AMENDMENT NO. 1 APRIL 2001
TO
IS 1759 : 1986 SPECIFICATION FOR *POWRAHS*
(*Second Revision*)

FIG. 2A AGRI *POWRAH* 1.4 kg

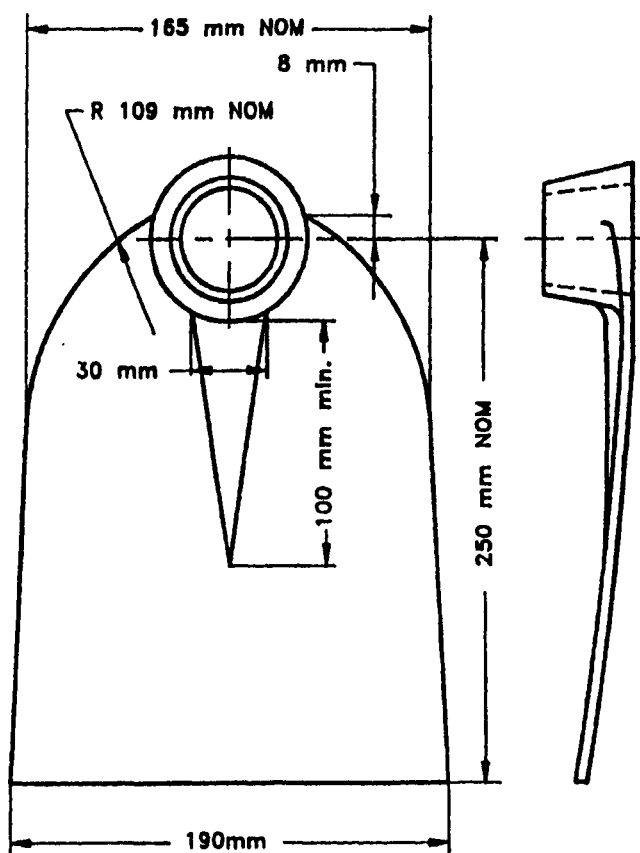
(*Pages 2 and 3, Fig. 2A, 2B and 2C*) — Substitute the following for the existing figures:
